24-AUG-2005

SUBJECT: ON Semiconductor Product Bulletin #15003

TITLE: Tape and Reel packaging change for SC70-5 Package

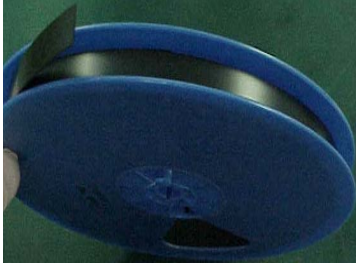
ON Semiconductor is pleased to announce a quality improvement in the Tape and Reel packaging procedure for SC70-5 package. Instead of having a leading segment of empty pocket tape at the beginning of each reel, ON Semiconductor will begin utilizing a black protective plastic belt as the leader for each reel.

Reel with 3k units

Black protective belt

Wound protective belt on reel

Lock with conductive grid tape
